NEW YORK CITY DEPARTMENT OF CORRECTION

**ADDENDUM #4 PIN 072202009CPD**

**George R. Vierno Center (GRVC) State of Good Repair**

**DESCRIPTION OF CHANGES**

E-121.00

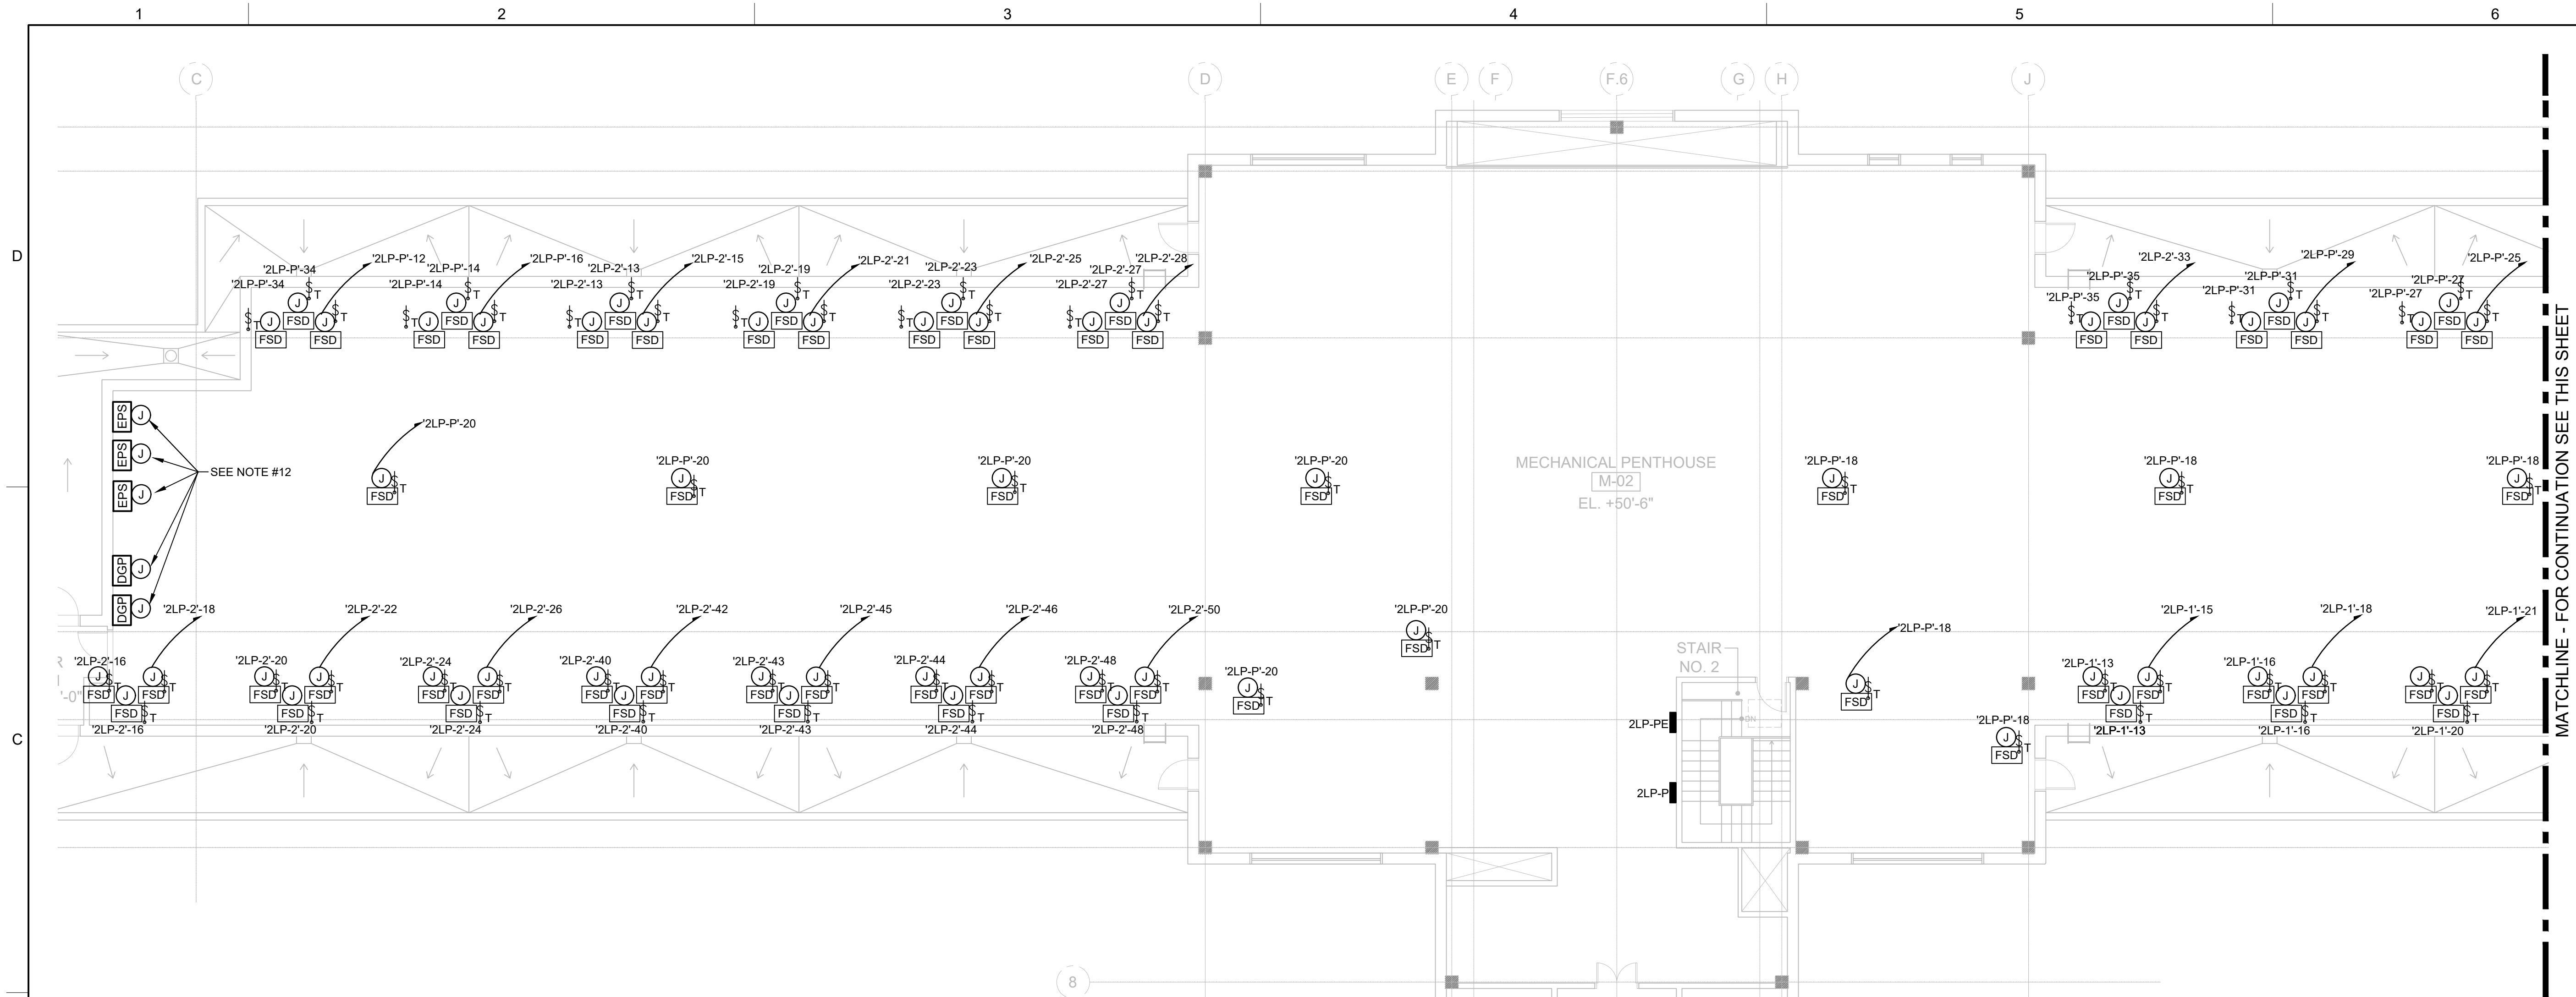
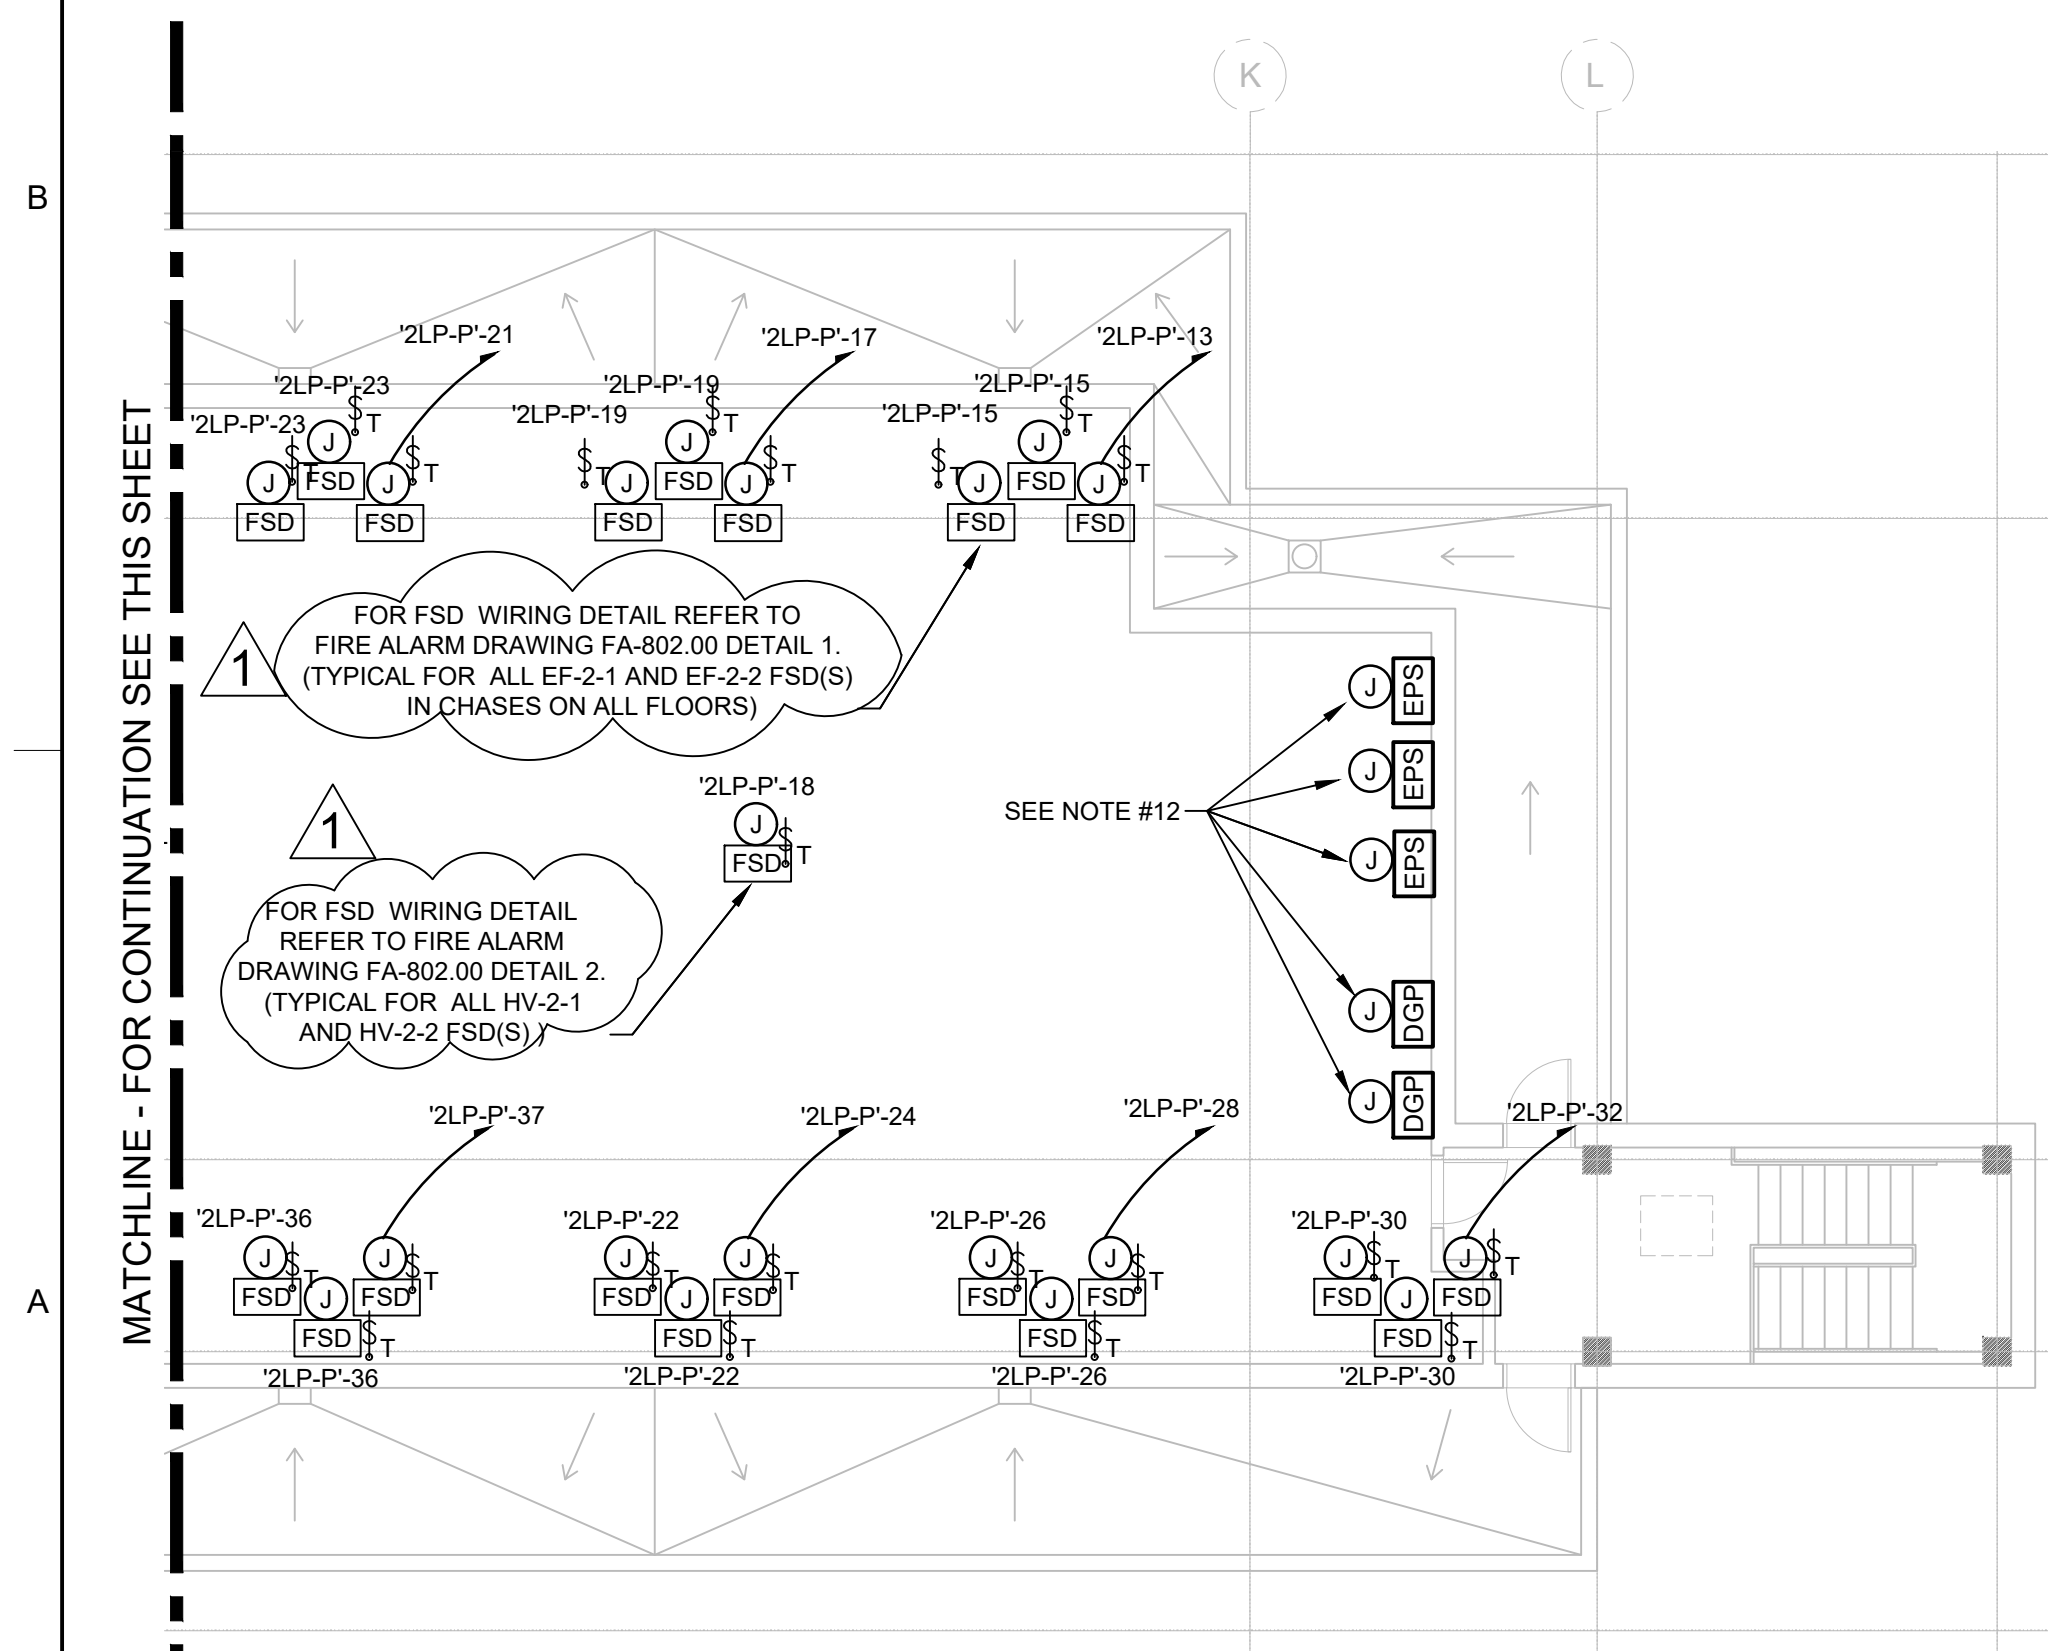
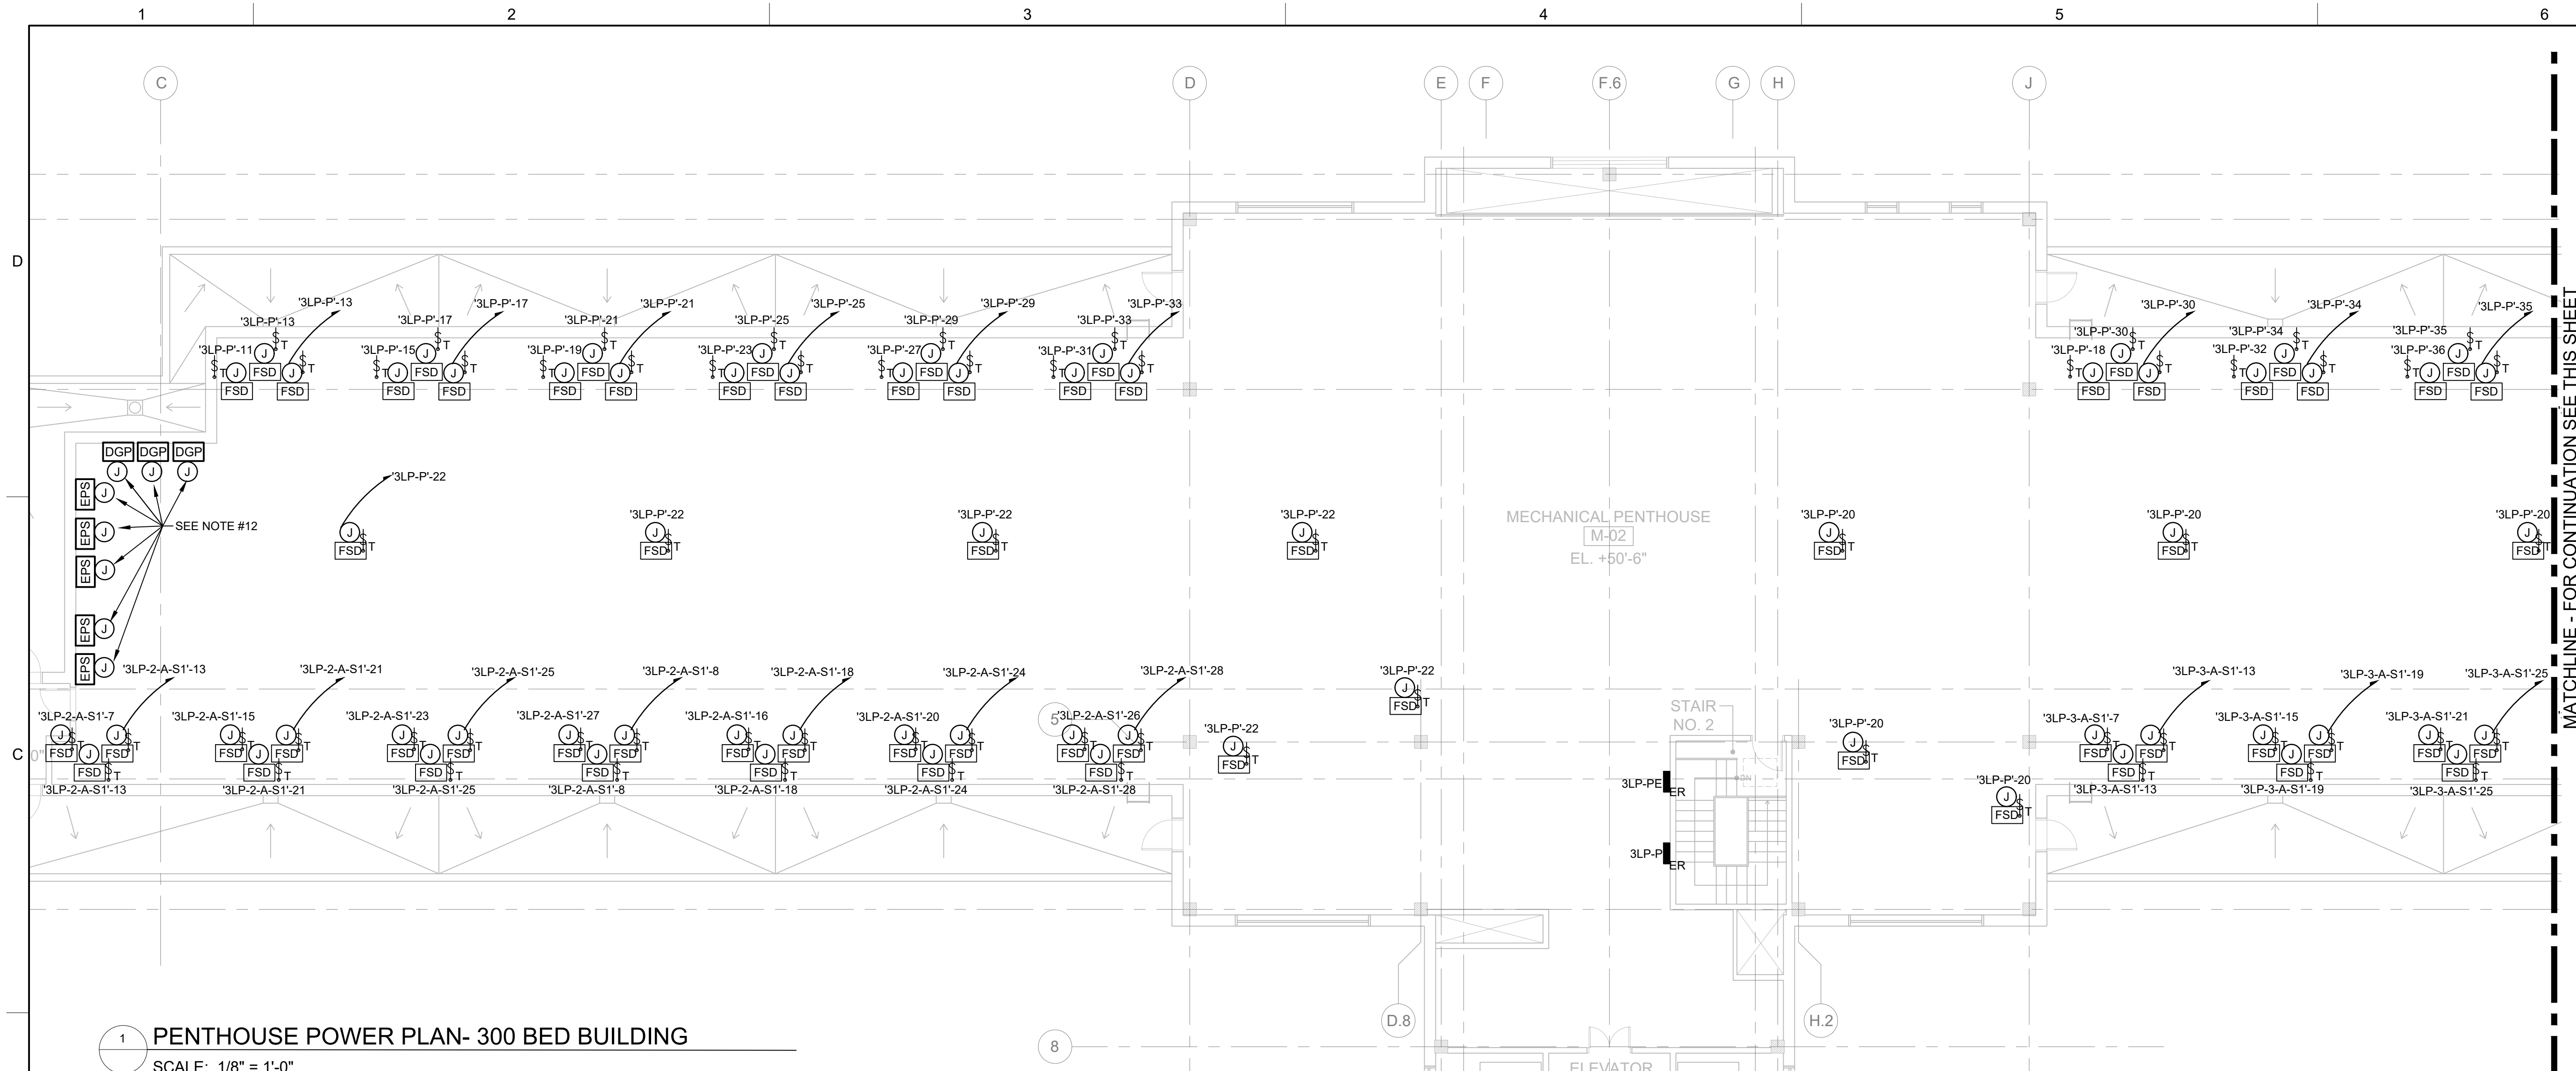
- 41. E-121.00:** Notes regarding FSD detail serving mechanical units have been updated
- 42. E-129.00:** Notes regarding FSD detail serving mechanical units have been updated.
